Modification of AE 5090 (later than June 2007) from 1 Watt AM to 4 Watt AM
Please note: our delivery status is 1 Watt. Only in Spain the 4 Watt setting is allowed.

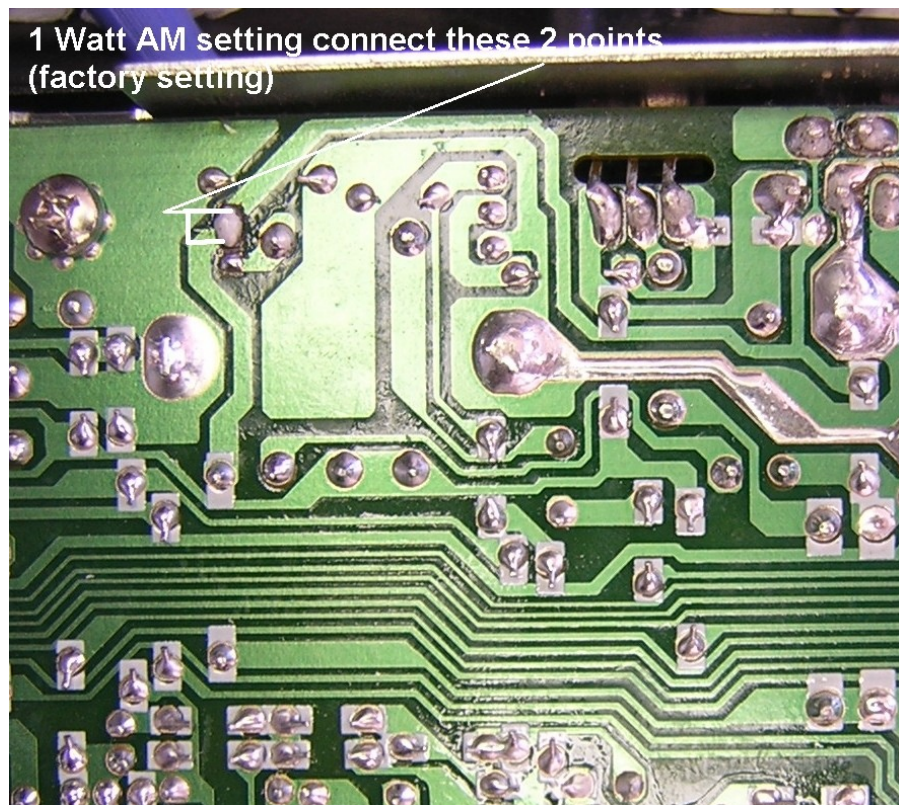
1 Watt

4 Watt AM: unsolder the connection for 1 watt and solder the lower 2 soldering points together
